# Revised P1 Panelboard 250 & 400A

# Revised P1 Panelboard FAQs

New Features and Options for "Revised P1" Offering compared to the "Original P1" panels

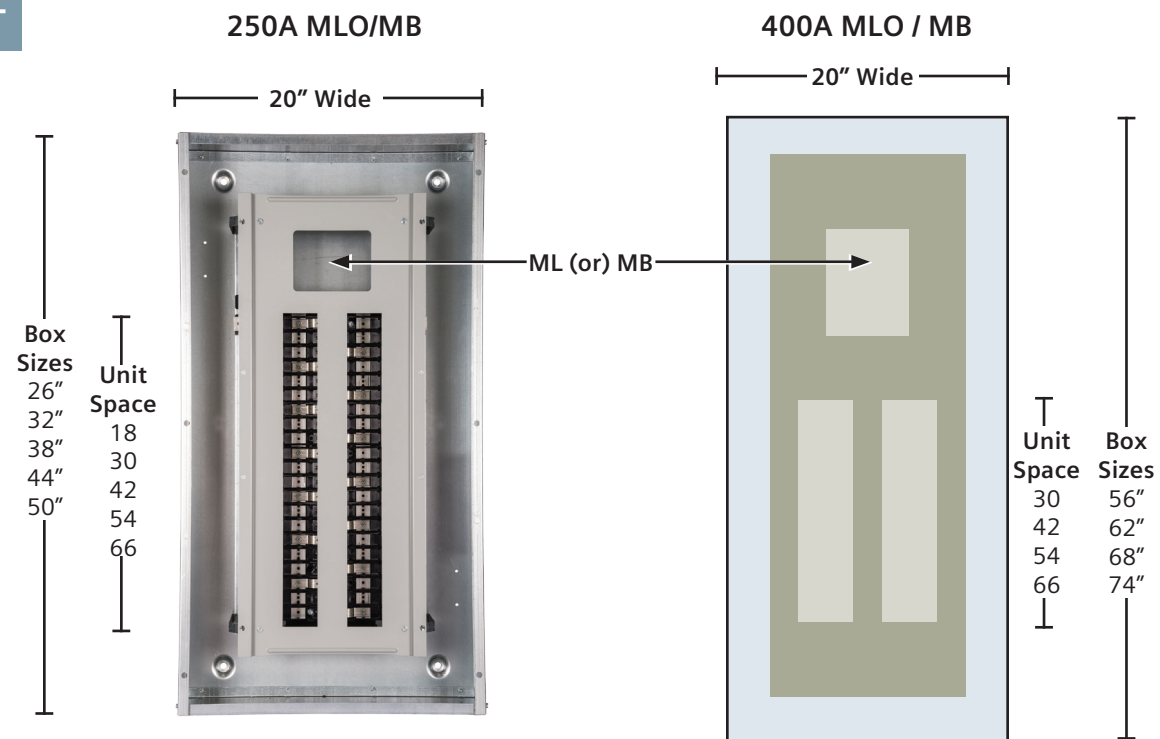
All FT and NFT are invertable in field – Top-feed or Bottom-feed

- Invertability
- Flexibility
